Model: Adonis-C2		Date: 23-May-01	No.: RB003001
Subject: Software Release Information		Prepared by: K. Takagi	
From: Technical Services Dept., GTS Division			
Classification:	<input type="checkbox"/> Troubleshooting <input type="checkbox"/> Part information <input type="checkbox"/> Action required <input type="checkbox"/> Mechanical <input type="checkbox"/> Electrical <input type="checkbox"/> Service manual revision <input type="checkbox"/> Paper path <input type="checkbox"/> Transmit/receive <input type="checkbox"/> Retrofit information <input checked="" type="checkbox"/> Other ()

Firmware history for the controller

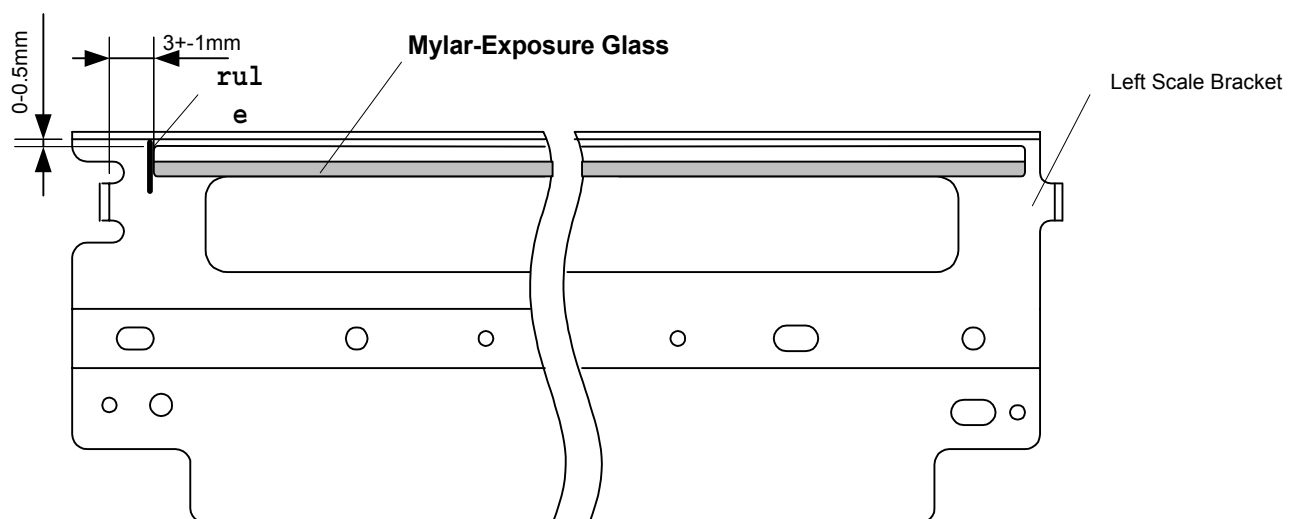
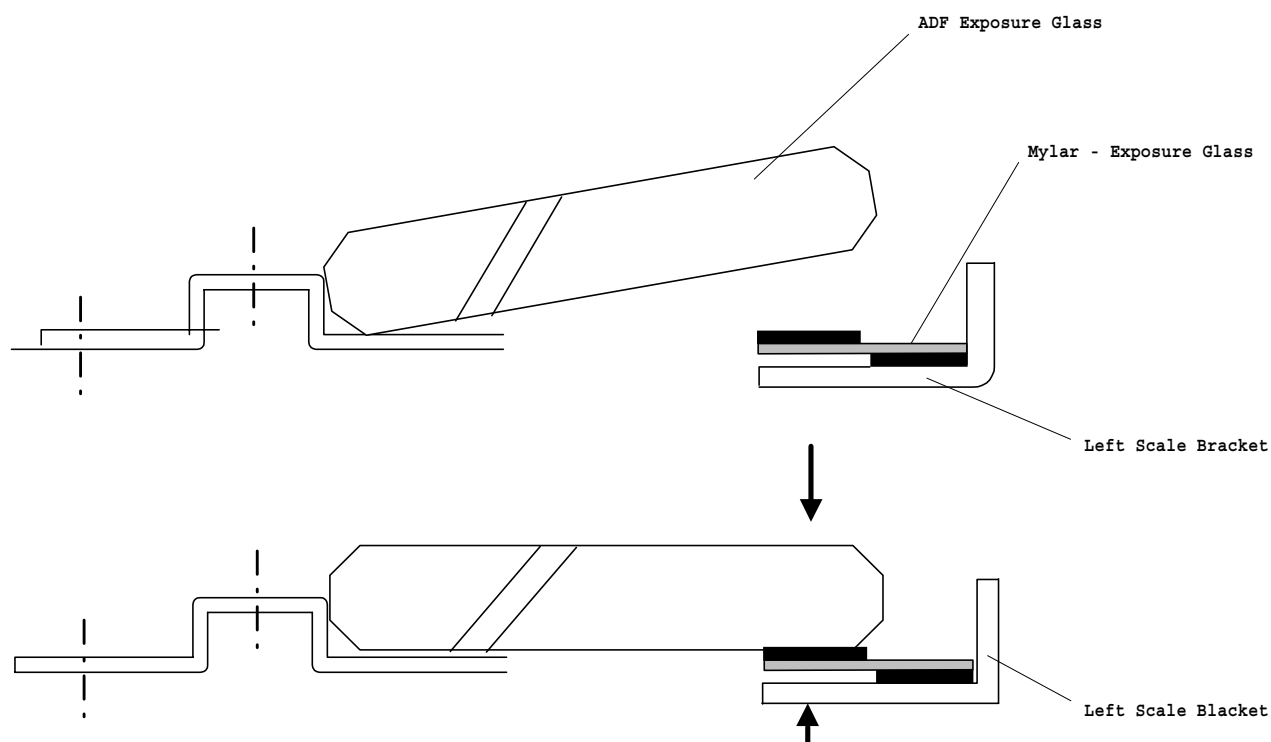
Dust or other foreign particles get caught in the gap between the ADF exposure glass and Left Scale Bracket, and later fall onto the exposure glass itself.

Add a strip of Mylar to seal the gap between the exposure glass and the bracket.

1. Remove the ADF exposure glass.
2. Remove the Mylar already attached to the Left Scale Bracket.
3. Attach the new exposure glass Mylar as shown in the second illustration below.

Fig. 1:

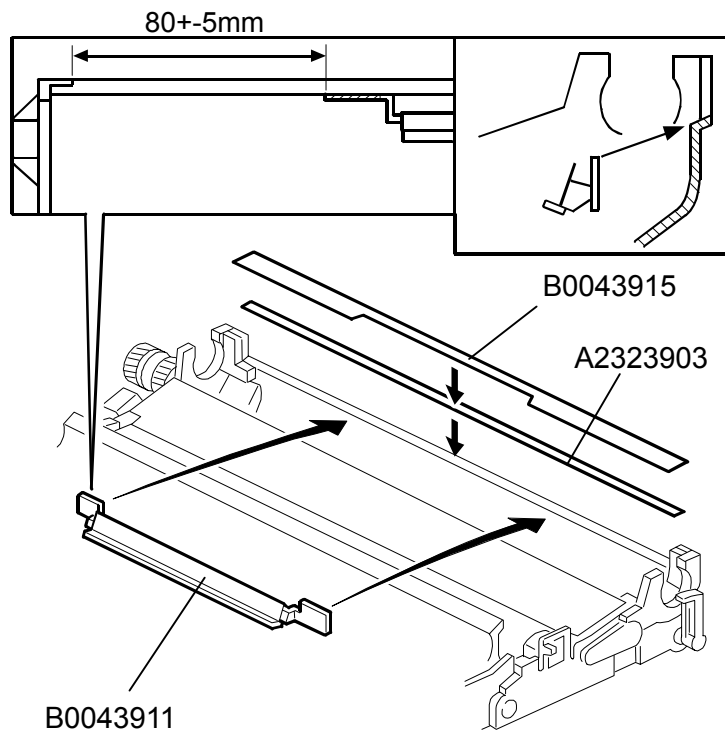
This RTB contains the replacement procedure for the modified parts in MB MA230073, which announced modifications applied to minimize dirtiness on the rear side of copies.

1. Remove the Transfer Unit, then the Transfer Belt and Cleaning Blade.
2. Peel off the old Entrance Mylar, then clean the surface of the attachment area underneath.
3. Clean out the inside of the unit thoroughly.
4. Attach the Remove Paper Dust Mylar (B0043911) as shown in Fig. 1.
5. Attach the Tape – Entrance Mylar (A2323903) and Entrance Mylar (B0043915) as shown in Fig. 1.

3.20 HARD DISK/CONTROLLER BOARD

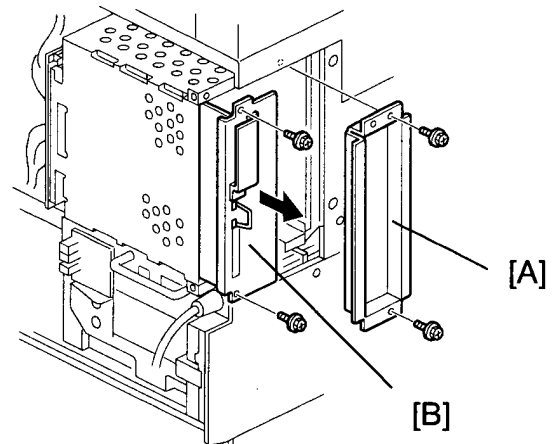
A new NVRAM is mounted on all Controller Boards supplied as service parts. However, since it is possible for an error to occur if the new board is installed with the new NVRAM, please add Step 4 below (**bold/italics**), which was missing from the Service Manual.

1. Left rear corner cover (☛ 3.8.1)
2. Expansion spacer [A] (🔩 x2)
3. Controller board [B] (🔩 x2)
NOTE: Use the wire handle to slide the HDD out of the expansion box.
4. ***Remove the NVRAM from the old Controller Board and install it on the new board.***

SYMPTOM

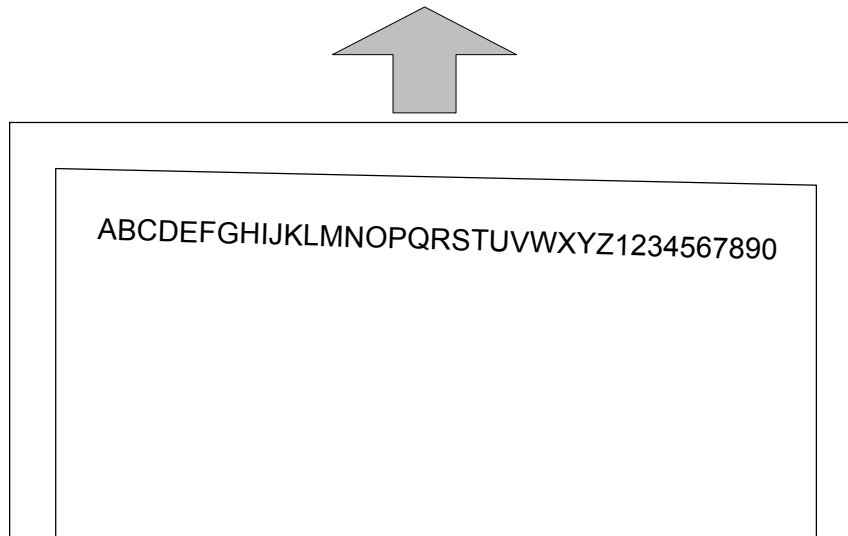
The edges of ADF or platen mode copies are in the shape of a parallelogram.

When the copy image comes out as shown above, please follow the flow chart on the next page and perform the necessary adjustment.
